# Zoning Staff Report

**Case Number:** ZC-24-016

## Zoning Map Amendment

**Site Location:** 2757 Moresby Street

PD SITE PLAN

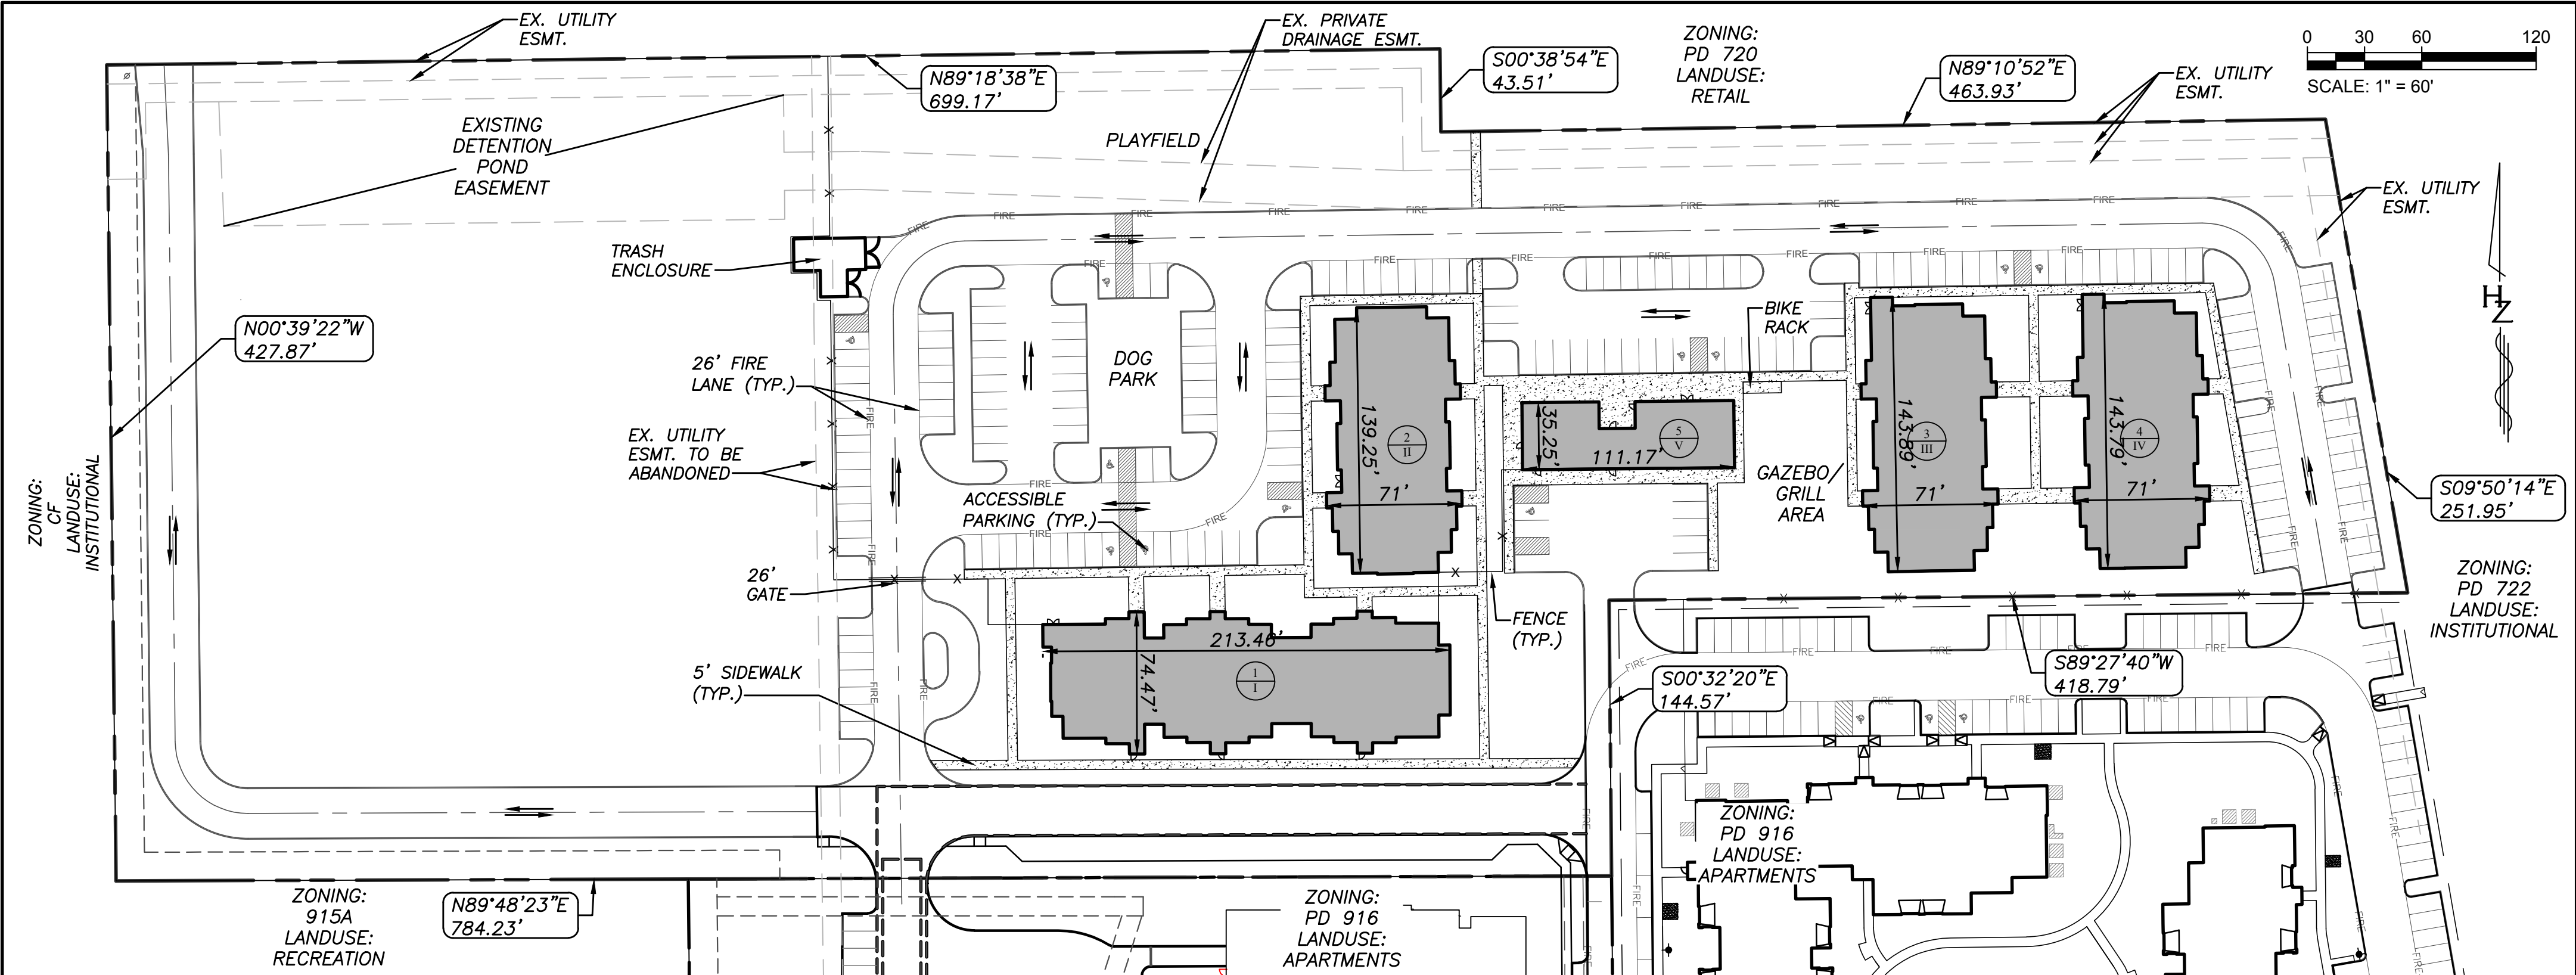
- Recalculate open space after removing detention pond and detention pond easement which cannot be counted as open space
- Building orientation: building does not face a public street

Fire lanes must be a minimum of 26' wide and provide hose lay to the exterior of each structure within 150', measured in a 5' wide unobstructed path from the edge of a marked fire lane or public street. That distance MAY be increased to 300' if the building is equipped with a fire sprinkler system.

Building/fire lane hose lay appears to be compliant for hose lay within 150'.

Vehicle gates are required to be a minimum of 20' wide when fully opened and equipped with Knox Locks. Permits are required.

Maximum of 600 ft. (300 ft. radius) of space between hydrants along a direct horizontal line.

Maximum of 500 ft. hose lay distance to all points of building.

FDC's for sprinkler and standpipe systems shall be located within 50 ft. of a dedicated street or fire apparatus access road and shall be within 150 ft. hose lay distance of the nearest fire hydrant. Each building shall be equipped with its own FDC, unless otherwise approved by the fire code official.

Hose lay from private hydrants cannot extend over lot lines. Additional hydrant(s) may be required to meet the above hose lay standards for each building and any Sprinkler System Fire Department Connections.

Shallow potential high water is present on site. There are 2 detention ponds and private earthen drainage channel easements located on site draining to the pond per TPW Plan Set W-2210.

Site will require an accepted drainage study prior to Commercial Grading Permit Issuance, Platting, IPRC Plan Acceptance, and Building Permit Issuance.
